Agenda Item # 4

SUB-003116-2024

Wolf Ridge Business Park Subdivision, Phase Two

- Subdivision approval to create one (1) legal lot of record from one (1) metes-and-bounds parcel.

DETAIL SITE PLAN

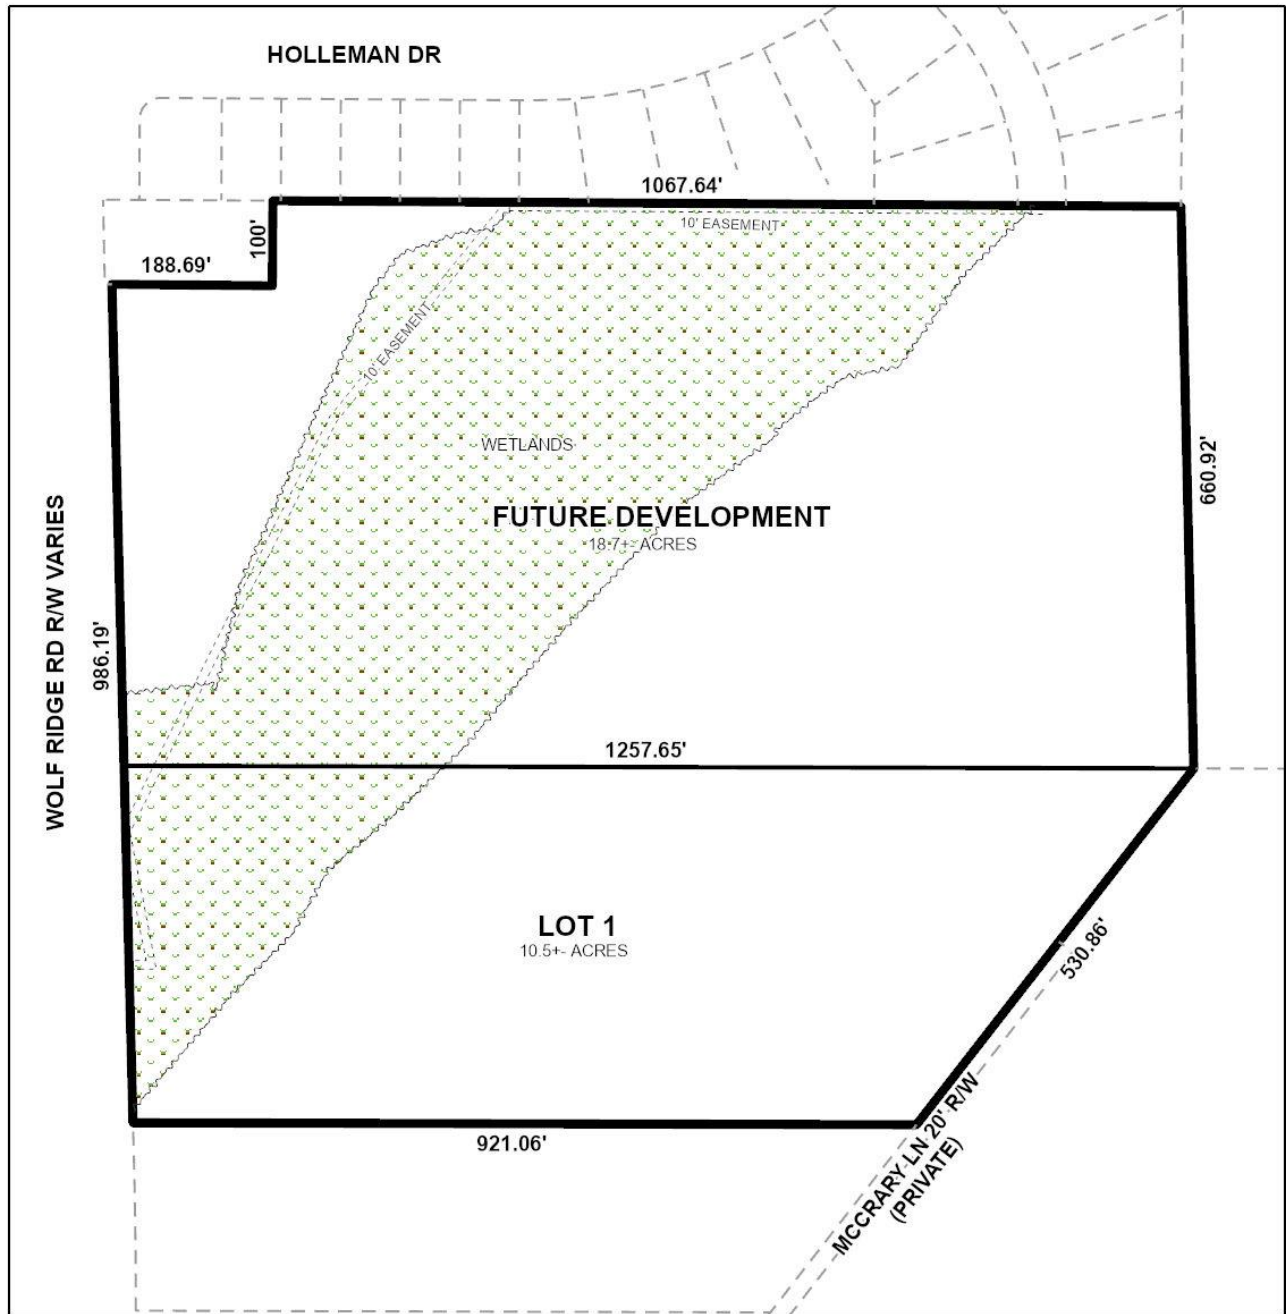
- B. Revise the FINAL PLAT to show only the ONE LOT that is proposed for this subdivision request.
- C. Revise the written legal description to include only the proposed subdivision boundary for the proposed ONE LOT subdivision.

- D. Delete the Line Table for lines L1 and L2. They are not included in this ONE LOT subdivision.
- E. Revise NOTE # 13 – Delete “(FLIGHT __, #__)”
- F. Revise NOTE #13 – Revise “...Lot _ - _____ SF” to “... LOT 1 – NONE.”

- G. Provide a note that a 25' riparian buffer may be required, during development, along the edge of anything considered by ADEM to be a water of the state.

- H. Add a note that sidewalk is required to be constructed, and/or repaired, along the frontage of each lot, or parcel, at time of new development or construction, unless a sidewalk waiver is approved.

The proposed lot has frontage on Wolf Ridge Road, a Minor Arterial Street requiring a 100-foot-wide right-of-way. The preliminary plat depicts a varying right-of-way at this location. As such, if approved, the Final Plat should be revised to illustrate the minimum existing right-of-way width or a 100-foot right-of-way along Wolf Ridge Road (whichever is greater).

No front yard setback is illustrated on the preliminary plat. Section 6.C.8. of the Subdivision Regulations requires the minimum front yard setbacks of the underlying zoning district and sub-district to be illustrated along all streets adjoining the subdivision. As such, if approved, revision of the plat should be required to illustrate a 25-foot front yard setback along Wolf Ridge Road, adjusted for any required dedication.

As mentioned, no easement is illustrated on the preliminary plat facilitating what appears to be cross access between the subject site and the adjoining lot to the South. There is a reference to the easement in the associated property deed, but the Final Plat should be revised to depict the easement facilitating cross access between the two sites.

1. Revision of the plat to illustrate the minimum existing right-of-way and, if less than 100 feet, dedication to provide 50 feet from the centerline of Wolf Ridge Road;

3. Revision of the plat to illustrate a 25-foot front yard setback along Wolf Ridge Road, adjusted for any required dedication;
4. Revision of the plat to depict the easement facilitating cross access between the two sites;
